Re: Septic System Alteration Waiver
Municipality: Clinton Township
Block: 16 Lot: 40
Location: 24 Old Mountain Road

This department has septic alteration plans dated March 14, 2023 designed by Fine Engineering, LLC, to correct a malfunctioning system to an existing 4 bedroom dwelling with no expansion as stated on the application. The design is in full conformance with 7:9A "Standards for Individual Subsurface Sewage Disposal Systems" except for the following waivers that will need to be acted on by the Board:

SEPTIC SYSTEM ALTERATION DESIGN

BLOCK 16, LOT 40

WAIVER(S)
DISTANCE FROM WELL TO DISPOSAL FIELD <100 FT.
EXISTING 62 FT.
PROPOSED 74 FT.

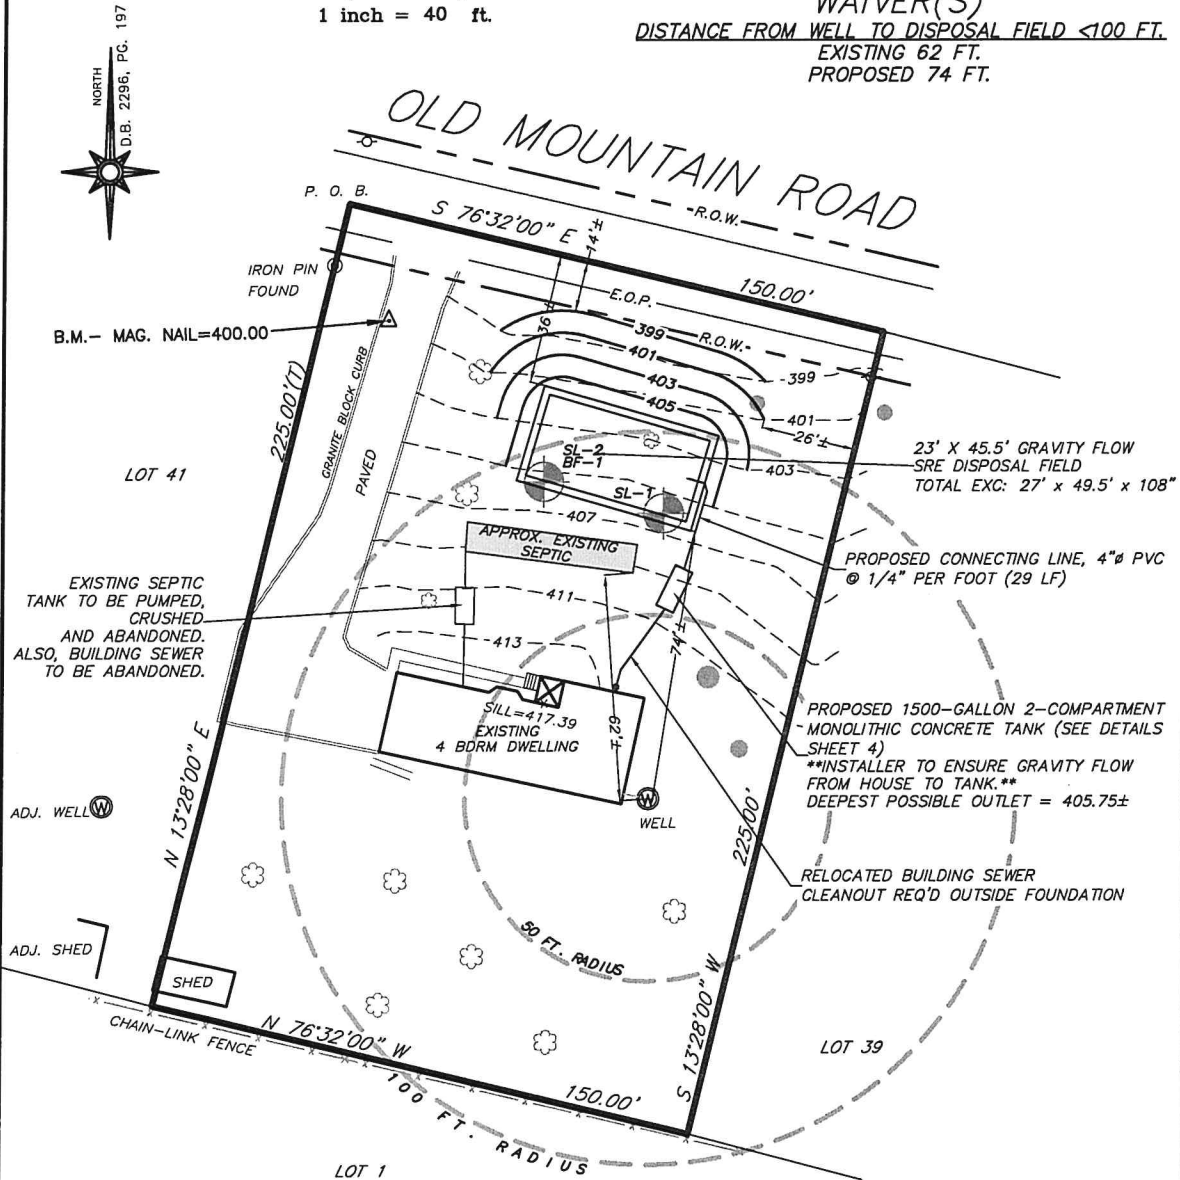
1. The proposed disposal bed will be only 74 feet from the existing well, which does not meet the minimum 100-foot setback requirement by code. The distance can be reduced according to 7:9A-4.3 to 50 feet provided there is a minimum of 50 feet of casing in the well. Due to the age of the well, the engineer has proposed to install an Ultra Violet treatment device on the well for added protection and a water test for coliform after treatment has been installed.

Since this is a malfunctioning system and according to 7:9A 3.3(e) 2 i and ii and the system is closer to being in full conformance with the chapter than the original system, the Board can consider the waiver request.
